206. ZONING BY-LAW AMENDMENT FILE Z.16.003
SITE DEVELOPMENT FILE DA.16.007
SITE DEVELOPMENT FILE DA.16.089
PENGUIN-CALLOWAY (VAUGHAN) INC.
WARD 4 - VICINITY OF MILLWAY AVENUE AND APPLE MILL ROAD
(Referred)

Report of the Deputy City Manager, Planning & Growth Management, Interim Director of Development Planning and Senior Manager of Development Planning, dated December 6, 2016

Revised Site Plan (File DA.16.007)

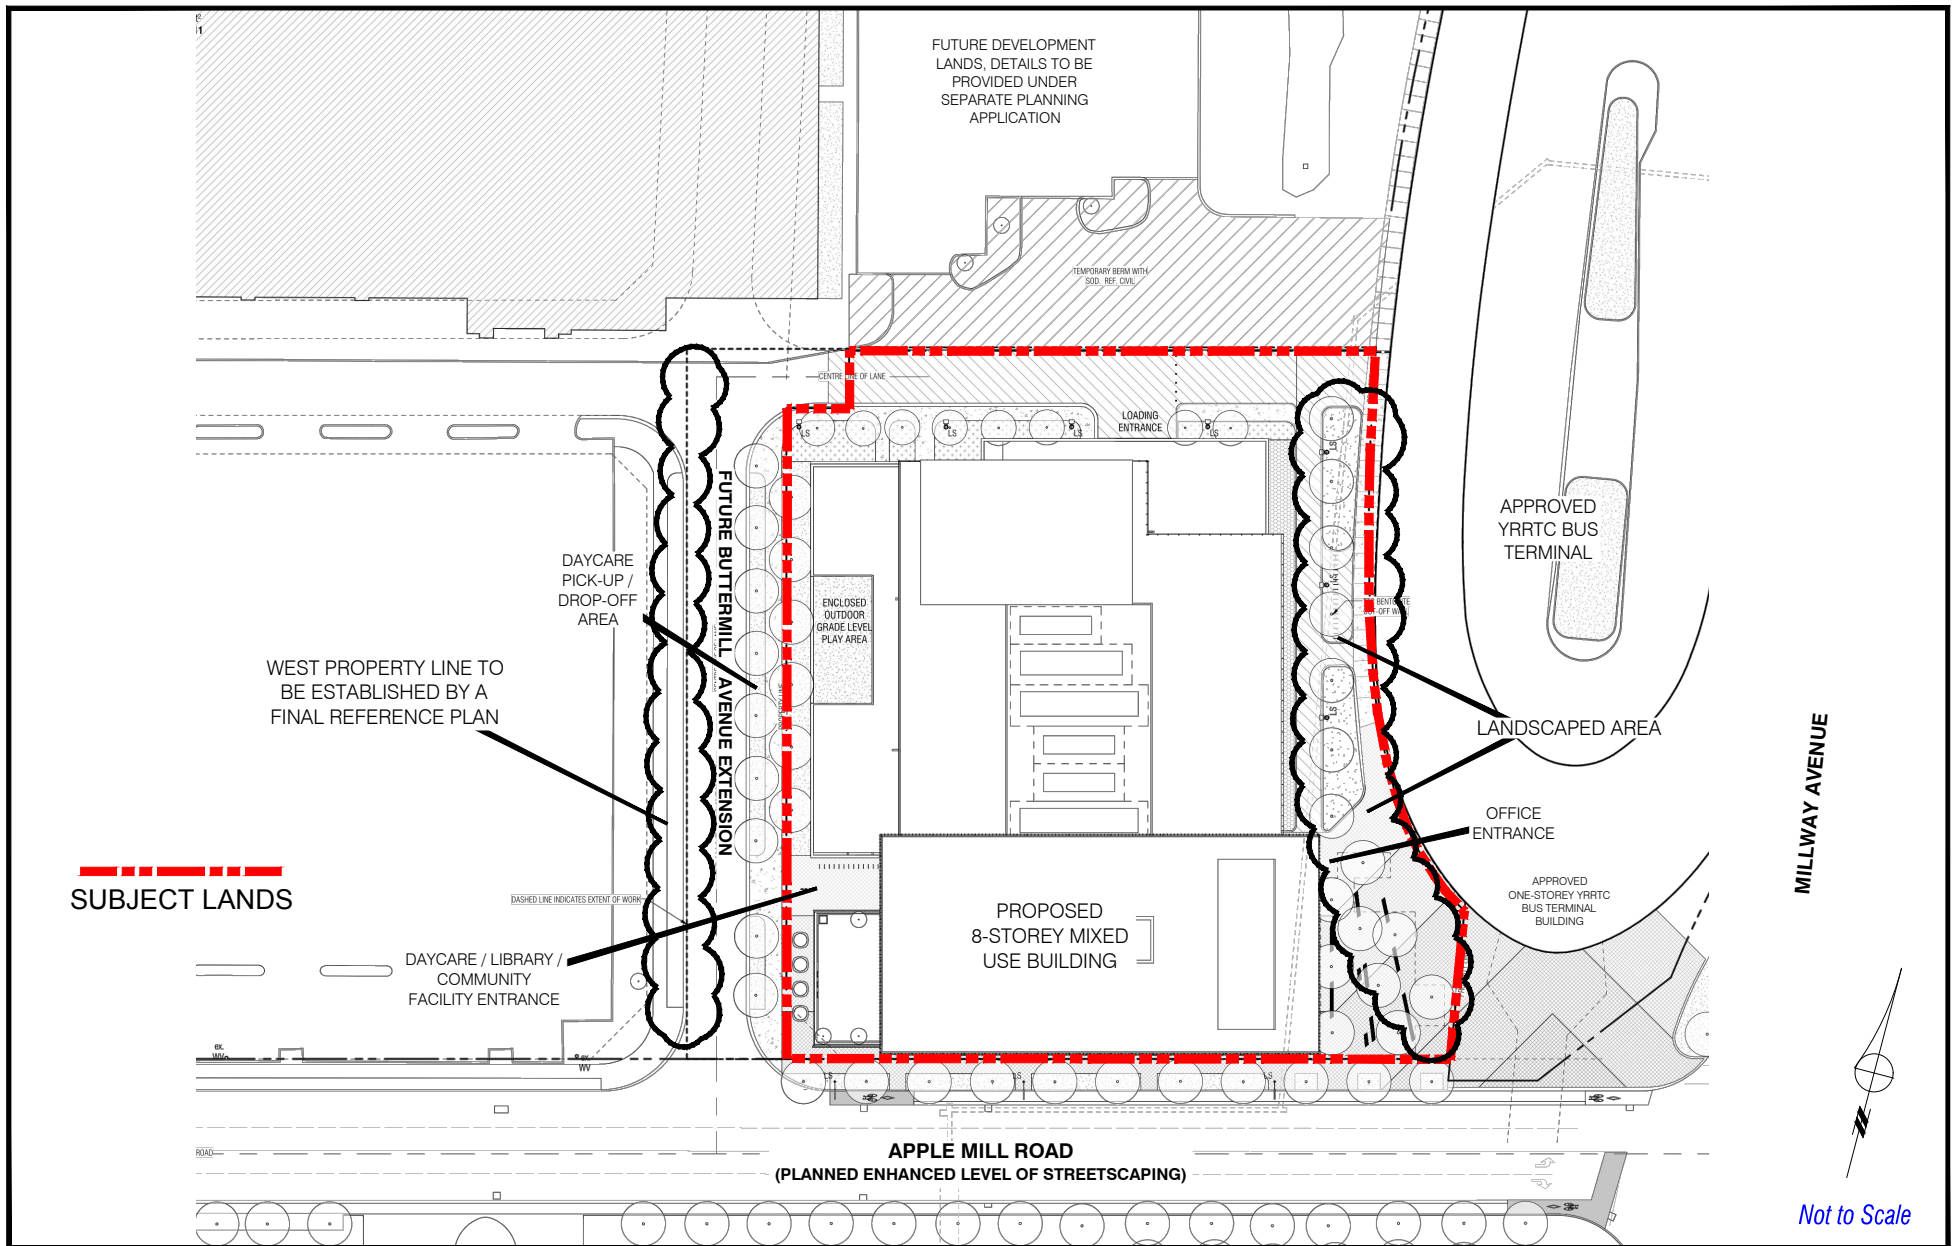
- i) The DRP encouraged the Owner to revisit the podium expression. More animation of the podium was encouraged.
- ii) The main entrances of the building should be more pronounced and the west entrance could be treated in a much more fun and playful way. For instance, planes could project out of the building, and colour could be added to the soffits and under surfaces as a wayfinding device.
- iii) The treatment of the penthouse floor is foreboding and appears very top heavy and could be designed to be less conspicuous.

The Owner responded to the DRP's comments with the revised proposal shown on Attachments #6 to #12. The revised development proposal incorporates colour and fritted glass treatment at the podium level, specifically the podium will be activated with visible uses (community centre gym) along the north of the building. The main entrances have designed with more prominence and greater expression. Though not fully depicted on Attachment #12, the building design will incorporate a stepped back roof line to provide articulation to the building. The Vaughan Development Planning Department is satisfied that the revised plans appropriately respond to the DRP's comments.

Red-Lined Site Plan (DA.16.089)

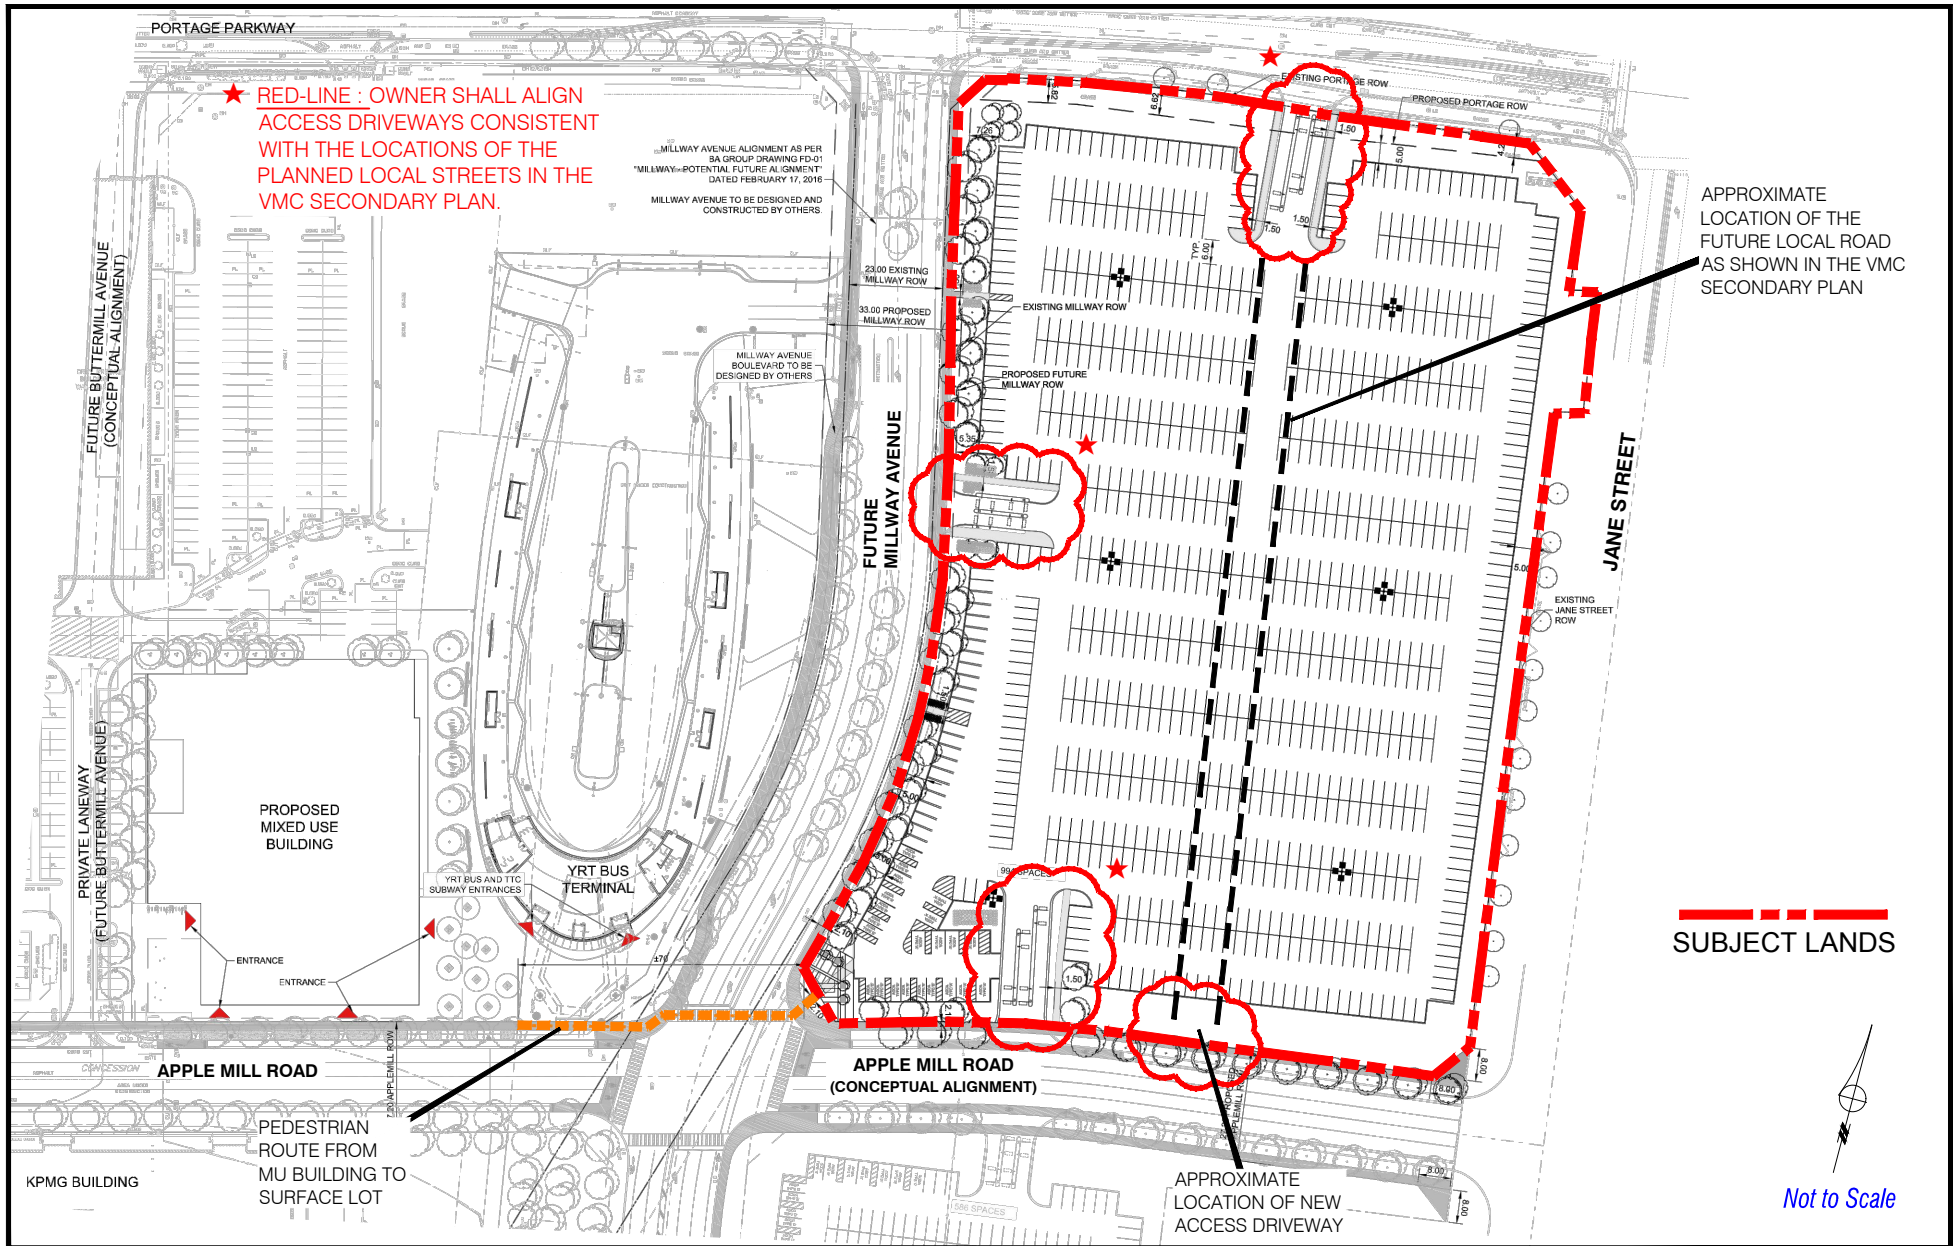
The Vaughan Development Planning Department recommends the approval of a temporary surface commercial parking lot consisting of 976 parking spaces, as red-lined on Attachments #13 and #14, subject to the Owner entering into an agreement with the City, which will include the following triggers for the ultimate removal of the parking lot the following conditions:

Access driveways to the temporary surface commercial parking lot are proposed on the Apple Mill Road extension (full move access) and Millway Avenue and Portage Parkway (right-in and right-out). The Owner has agreed to align the access driveways for the temporary surface commercial parking lot to be consistent with the general location of a planned local street shown in the VMC Secondary Plan. The temporary proposed parking lot site plan shown on Attachments #13 and #14 has been red-lined to reflect this change. Each access driveway is currently proposed to be gated and controlled, but this may be reconsidered to avoid negative traffic impacts.

The Vaughan DEIP Department, Transportation Planning Division, has reviewed the proposed temporary surface commercial parking lot and provided the following comments:

- i) the Owner shall provide an access operations review study to address the proposed vehicular and pedestrian impacts on adjacent City streets, intersections, and transit operations. The study shall include a Functional Plan for the proposed accesses on City Roads. The Functional Plan must detail the curb radii, throat width, sight triangles details, lane configuration and auxiliary lanes requirement, if any, at City road/intersections (interim and ultimate conditions);

- ii) the access locations at Portage Parkway and Apple Mill Road shall be aligned consistent with the location of the future north-south City's road, as identified in the approved VMC Secondary Plan;

- iii) the Owner shall provide drawing details of the proposed access at Portage Parkway and Apple Mill Road;
- iv) the proposed access to Portage Parkway shall be restricted to right-in and right-out movements only;

- v) 22 accessible parking spaces shall be provided, as required by the Accessibility for Ontarians with Disabilities Act (AODA), shall be shown on the plan and must be verified by the Vaughan Building Standard Department;

- vi) include a traffic signage plan that specifies stop signs, one-way signs and do not enter signs; and,
- vii) a reference shall be included on the drawings that the proposed driveways will be constructed with heavy duty asphalt from back edge of the municipal curb to property line and this area should be highlighted on the site plan.

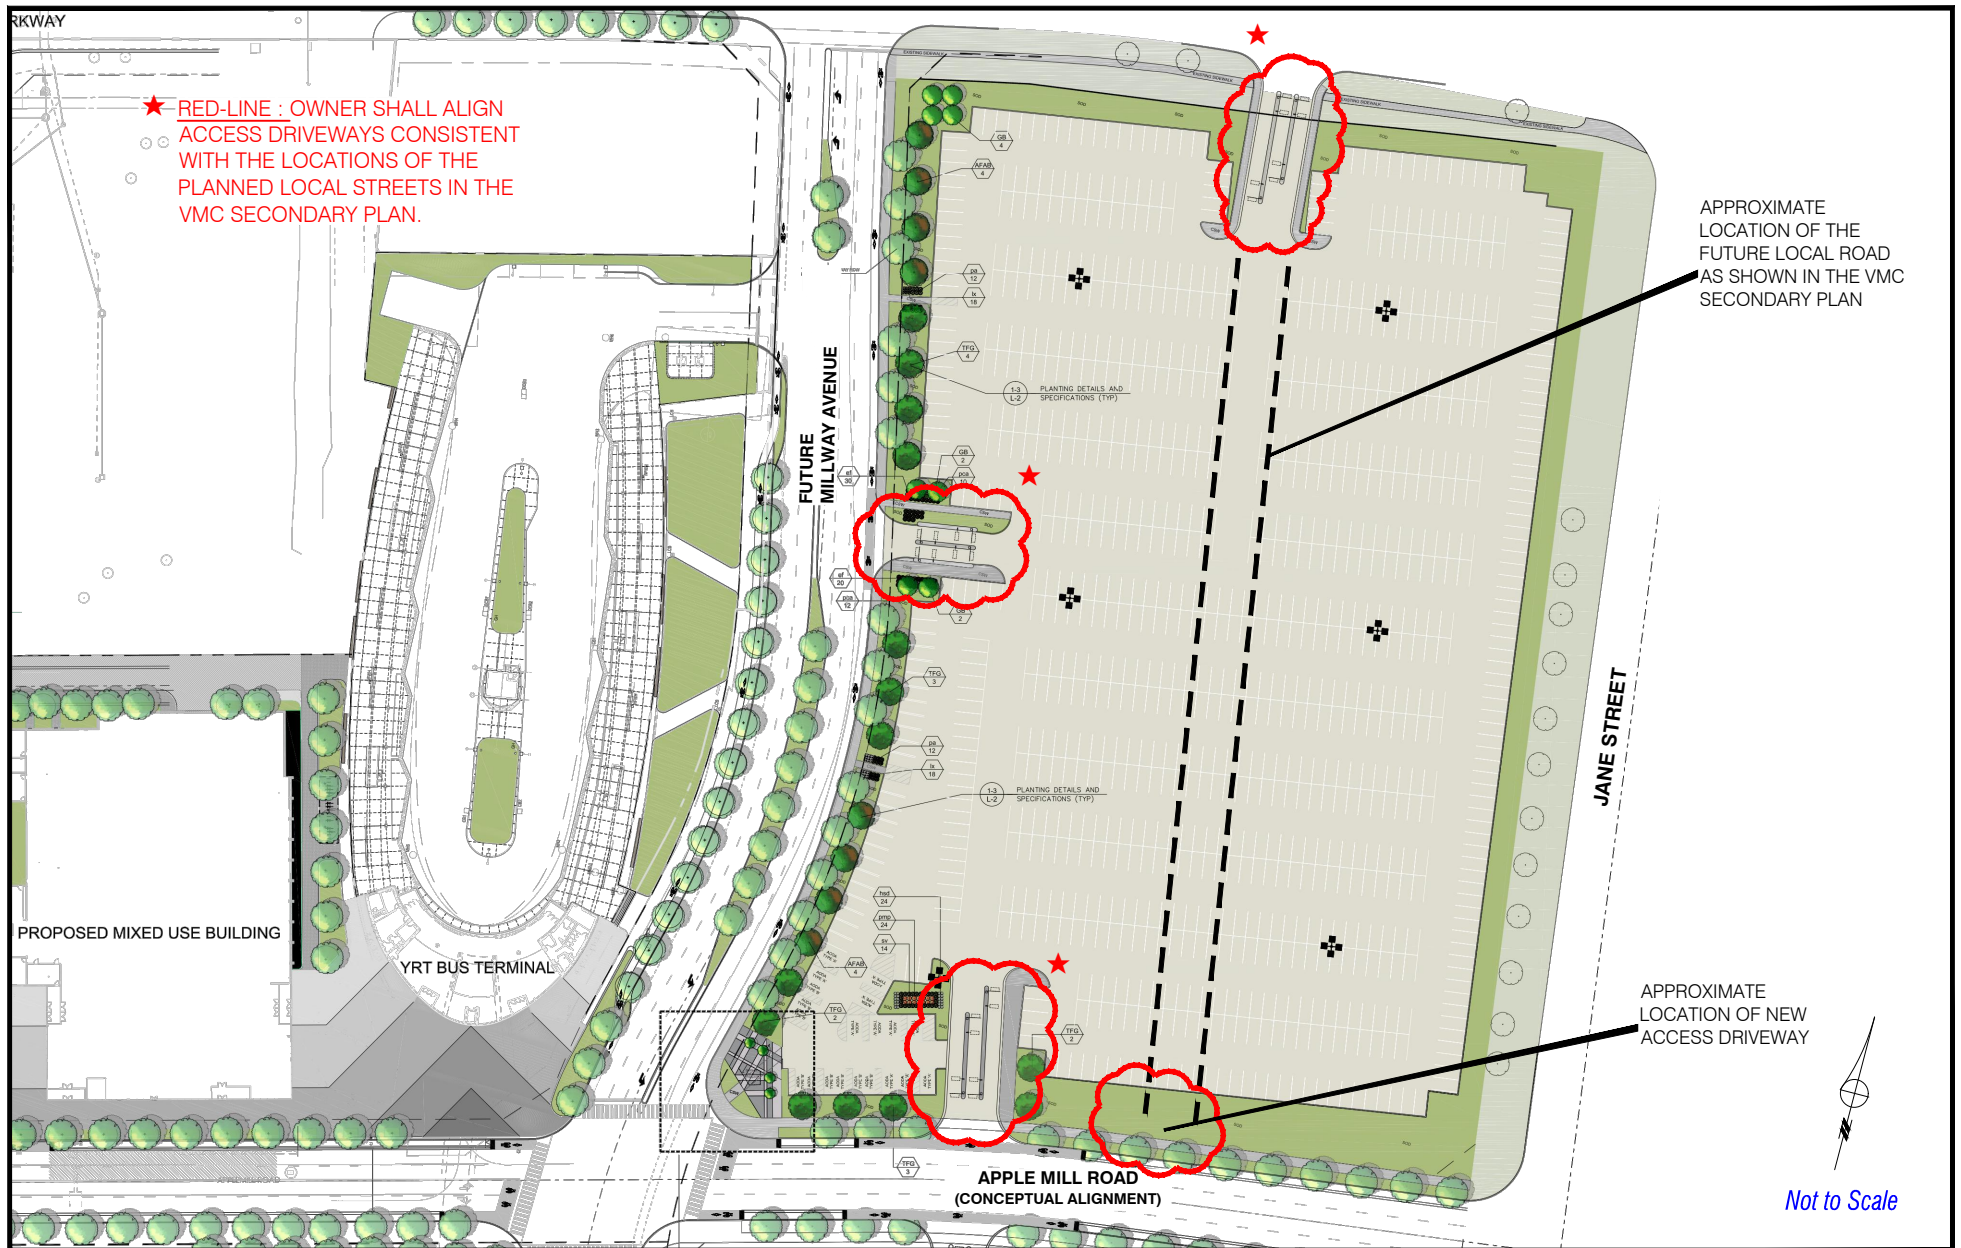
The landscape plan for the temporary surface commercial parking lot is shown on Attachment #14. The Urban Design and Cultural Heritage Division of the Vaughan Development Planning Department has reviewed the proposal and advises that Millway Avenue is defined as a premium level of service streetscape in the City-Wide Streetscape Implementation Manual and VMC Streetscape and Open Space Plan (VMC SOS Plan), and the design of the east boulevard must conform to the design specifications outlined in the Terms of Reference for this capital project. The Owner has agreed to make the necessary arrangements to fund and implement the ultimate landscape design solution for Millway Avenue, from Regional Road 7 to Portage Parkway, which will be subject to a separate Development Agreement.

The Owner has been advised that the landscape treatment along Jane Street must be improved with buffer plantings, temporary sidewalk, and enhanced screening measures. Additionally, the design of the Portage Parkway streetscape must be coordinated with the concept developed through the recently approved Environmental Assessment (EA) for the Portage Parkway widening and easterly extension to west of Black Creek (Part A). The widening of Portage Parkway is discussed in the Vaughan Development Engineering and Infrastructure Planning Department section of this report.

The Owner is further advised that the plaza at the north-east corner of Millway Avenue and the Apple Mill Road extension must be designed and coordinated seamlessly with the Millway Avenue streetscape concept and adjacent public spaces, including the YRRTC Bus Terminal plaza area and Transit Square/TTC Plaza as part of the broader vision for the mobility hub landscape. All site furnishings must conform to the material palette outlined in the VMC SOS Plan. The Owner is further encouraged to introduce breaks in the expanse of parking with the introduction of a significant planting islands with bioswale features to support storm water management. All wayfinding signage must be reviewed by the City.

- e) deleting the reference to “temporary sidewalk” in the first sentence of the third paragraph of item b) of the Landscape Plan/Urban Design section and replacing it with “safe pedestrian connections”, to read:

“The Owner has been advised that the landscape treatment along Jane Street must be improved with buffer plantings, safe pedestrian connections, and enhanced screening measures.”
